Planning Application No. A/TM-SKW/124

Table A: Responses to Departmental Comments

Temporary Shop and Services for a Period of 3 Years at Lot 240 S.B (Part) in D.D.385, So Kwun Wat, Tuen Mun, New Territories

Layout Plan

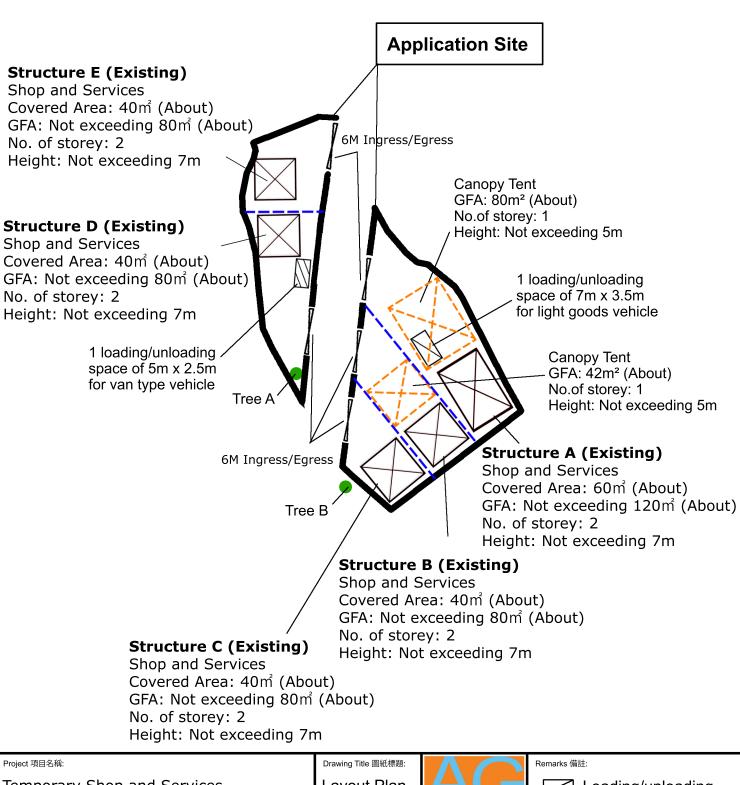
(1) As observed from DPO's photo records dated 01.02.2024, the Site is already occupied by temporary structures of the current proposed layout, no existing trees/ significant vegetation is found. However, according to the FI submission received on 13.07.2022 under previous planning permission (No. A/TM-SKW/115) made by the same applicant, it is observed that 2 existing trees were proposed to be preserved with trees location and photos provided. As no information on existing tree/ landscape proposal is provided under this application, the Applicant is required to provide a Landscape Proposal with proposed landscape treatments/ mitigation incorporated in the proposed layout for review, in order to facilitate TPB's consideration on the application.

有關部門提及的兩棵樹木(Tree 1 & Tree 2),十分抱歉,申請人在早前的申請 No. A/TM-SKW/115 錯誤標示樹木位置,現時申請人重新在 Layout Plan上標示該 2 棵樹木的準確位置,並附上照片,讓部門再參閱。請看附件 2。

附件 2 的 Layout Plan 上面的兩棵樹木,分別為 Tree A 及 Tree B (請看上圖)。 Tree B 與 2022 年 7 月 13 日遞交之前申請 A/TM-SKW/115 時的補充文件的 Tree 1 是同一棵樹,之前申請人看錯位置,所以標記錯誤,現在重新標示清楚讓部門查閱。 至於之前規劃申請 A/TM-SKW/115 時的補充文件的 Tree 2 已由現時的 Tree A 取代。
